Subject: AP1000 COL Response to Request for Additional Information (TR 34)

Response to Request for Additional Information on Technical Report No. 34

RAI Response Number: RAI-TR34-CPN-01
Revision: 0

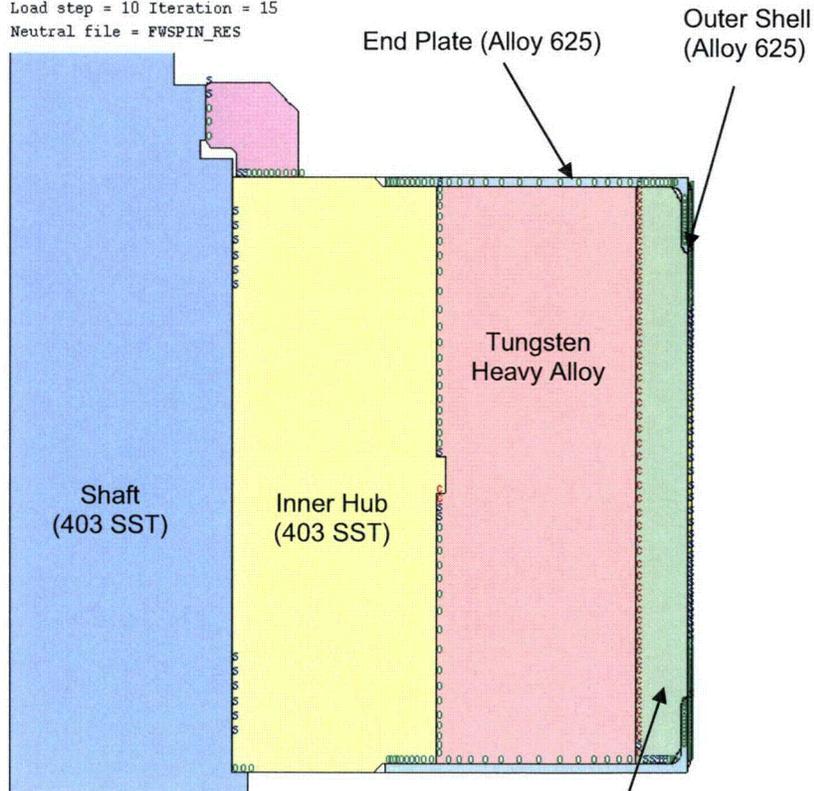
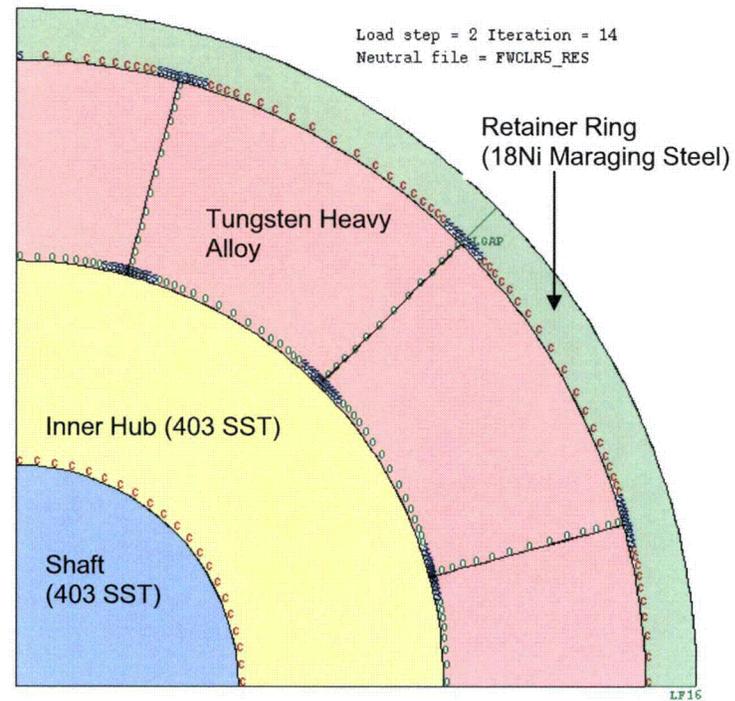
- a. What the term “bi-metallic” means.
- b. What the term “heavy metal alloy” means.
- c. Identify the materials of construction for all structural components of the bi-metallic flywheel?
- d. Provide a simplified sketch of the flywheel assembly showing various segments referenced in the DCD.

- a. The term bi-metallic refers to the 2 different structural materials that are used in the flywheel design. The flywheel design uses a central Type 403 stainless steel hub and an interference fit of an 18Ni maraging steel retainer cylinder placed over the outside of the assembly. The term bi-metallic does not refer to any type of special alloy or composite material.

- b. The term “heavy metal alloy” refers to Tungsten Heavy Alloy or WHA. The material will be per ASTM B-777, Class 4 and is produced by a mixture of loose metal powders consisting of 97% (weight) pure tungsten and 3% metallic powder binders such as copper, nickel or iron that are pressed and solidified by sintering.

- c. The inner most portion of a flywheel (Inner Hub) is a ring forging of Type 403 Stainless Steel (same material as the rotor shaft). Tungsten Heavy Alloy segments are placed on the outside diameter of the Inner Hub and held in place by a (Retainer Ring) ring forging of 18Ni maraging steel (AMS 6512: Composition – 18Ni – 7.8Co – 4.9Mo – 0.40Ti – 0.10Al with a 250ksi minimum Yield Strength) by means of a shrink fit. The Inner Hub and 18Ni maraging steel Retainer Ring are considered the structural materials of the flywheels. The flywheels are completed by assembling Alloy 625 End Plates and Outer Shell to prevent primary coolant from contacting the 18Ni maraging steel and Tungsten Heavy Alloy.

- d. See flywheel figures on the next page.

Retainer Ring
(18Ni Maraging Steel)
